26 BUSINESS AND ORGANIZATION COMMENTS

Submission 1839 (Lauren D. Layne, BAKER MANOCK & JENSEN, PC, June 22, 2020)

Re: San Jose to Merced Project Section Draft EIR/EIS Comment Letter

Figure 5-J
Diridon Station Area Off-Street Parking Supply within a Half-Mile Radius
 VTA's BART Silicon Valley—Phase II Extension Project

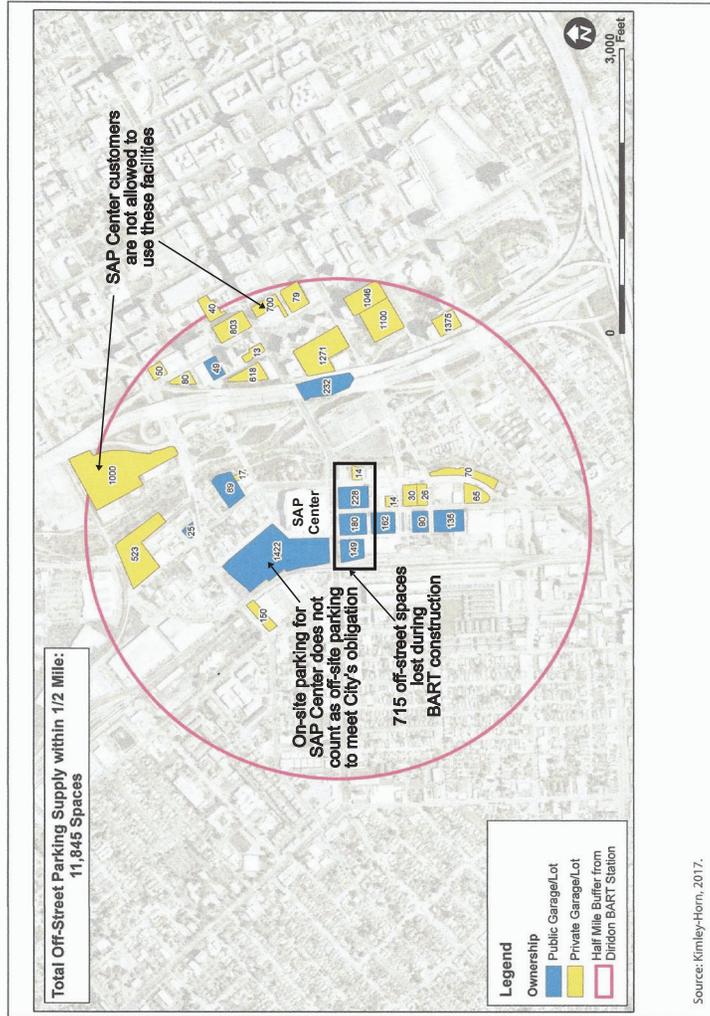
A fundamental flaw with the parking supply data shown in Figure 5-J is that the results are an inventory of striped parking spaces, not spaces that truly are available at any point in time. The results do not account for spaces that are reserved for particular users and do not account for spaces that are occupied by other parkers.

A related serious mistake also is exhibited in Figure 5-H in the Final SEIS/SEIR, which purportedly shows that 2,605 on-street parking spaces are available within ½ mile of the Diridon Station. The actual number of available public parking spaces is far less than shown in this figure, because the 1/2 mile area encompasses six residential parking permit areas established by the City of San Jose – Autumn/Montgomery, Cahill Park, Delmas Park, Garden/Alameda, Parkside, and St. Leo's. For streets in these areas, no general public parking is allowed; a motorist must display a residential parking permit in order to be allowed to park.

Figure 2
Parking Spaces Available for SAP Center Lost During
Eight Year Construction Period for BART Diridon Station

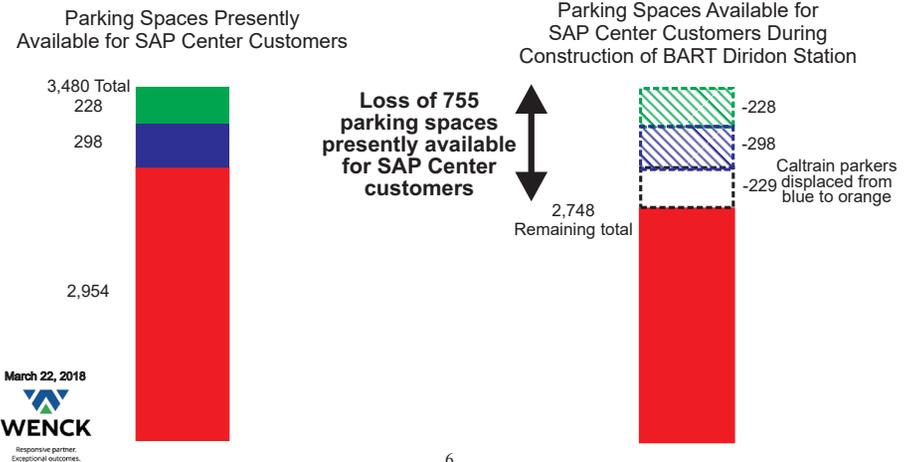
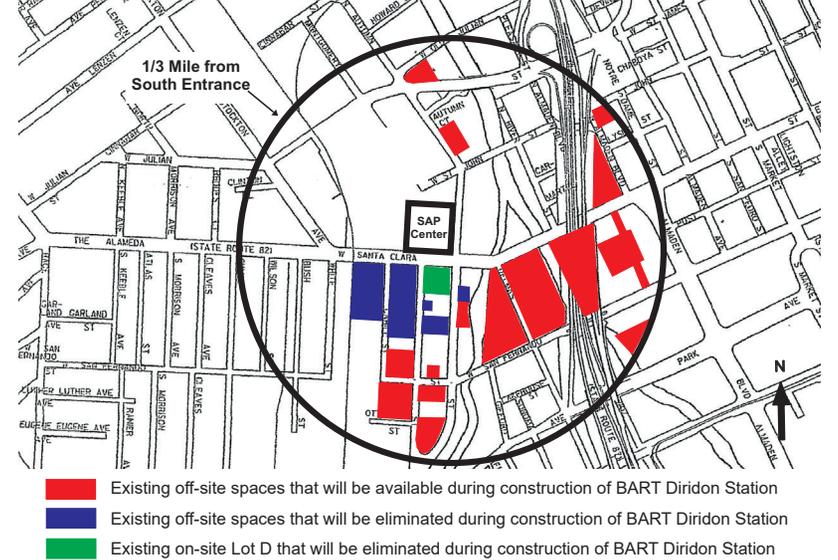
To overcome the above deficiencies in Master Response 2 and its inability to mitigate negative impacts caused by the loss of 755 parking spaces during the BART construction, an independent analysis has been completed regarding the impacts that would be caused by loss of parking for SAP Center during construction of the BART Diridon Station using generally accepted parking availability methodology. The results are shown in **Figure 2**. This figure shows three types of parking spaces within 1/3 mile of SAP Center that have been used for customer parking. The left bar chart shows that those parking facilities, together with a few on-street spaces, presently provide a total of 3,480 spaces available for SAP Center customers (3,252 off-site spaces plus 228 spaces in on-site Lot D). The right bar chart show that the available spaces will decline to 2,725 spaces (a loss of 755 spaces). This loss, which would be exacerbated if construction workers park in the 1/3 mile ring, will have severe negative consequences for SAP Center.
